FINAL REPORT

U.S. ARMY CORPS OF ENGINEERS

**EVALUATION & ASSESSMENT
OF PROPOSED ALTERNATIVES TO
RETROFIT/REPLACE THE EAST SPAN OF THE
SAN FRANCISCO-OAKLAND BAY BRIDGE**

October 27, 2000

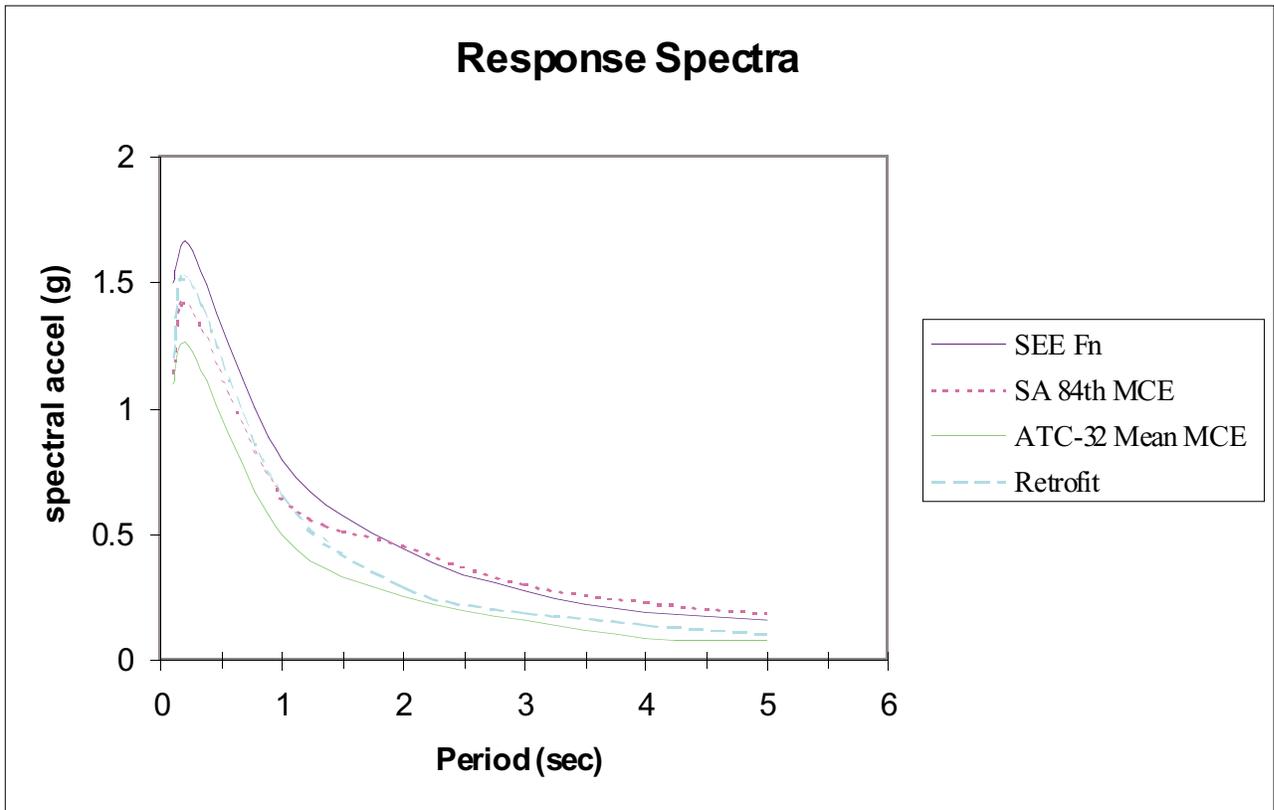
The SAS has not been evaluated or designed for the larger MCE event.

The Response Spectra graph above compares the various seismic events used to design the SAS. A comparison is made between the SEE and the MCE events for the replacement bridge. The dark, solid line depicts the SEE event, while the dotted line depicts the MCE. For this replacement bridge with its inherent period, the MCE is a greater force than the SEE.

1. Earthquake sources and MCE

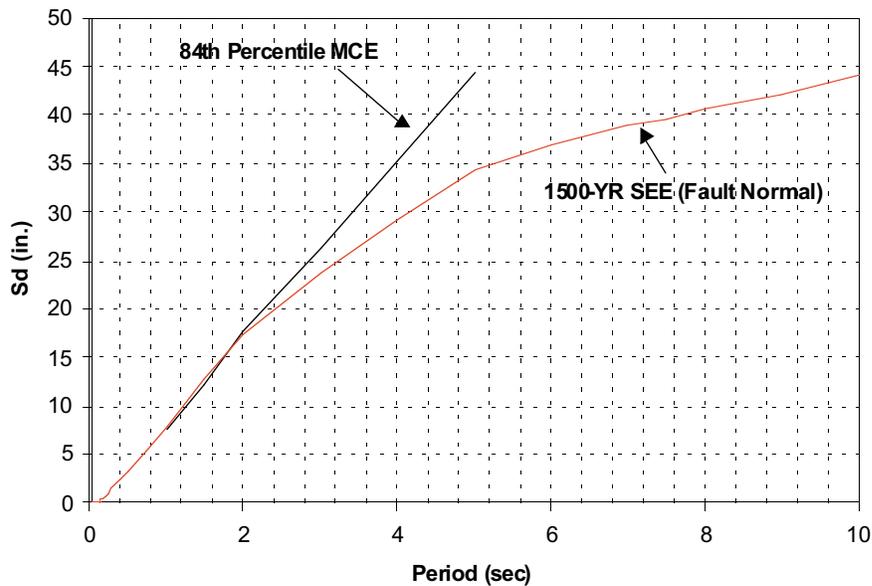
For the east span of SFOBB, the dominant earthquake sources are the Hayward fault at 9 km east of the Oakland Toll Plaza and the San Andreas faults at 18 km west of Yerba Buena Island. Other faults considered in the seismic hazard analysis include San Gregario, Roger's Creek Healdsburg, Green Valley, Calaveras, and Greenville.

The maximum credible earthquake (MCE) ground motions associated with the Hayward and San Andreas faults were used in the retrofit design and evaluation of the exiting bridge. The maximum magnitudes for these events were based on a study of seismic hazard for the northern California bridges. A moment magnitude of $M_w = 7.3$ was assigned to the Hayward Fault located 8 km from the east end of the east span and an $M_w = 8$ to the San Andreas Fault located 19 km from the west end of the east span. The 84th percentile MCE ground motions were developed for each event. According to the Geomatrix probabilistic hazard assessment [Geomatrix, 1992] the 84th percentile MCE ground motion is between 1000- and 2000-year return period equal hazard spectra.
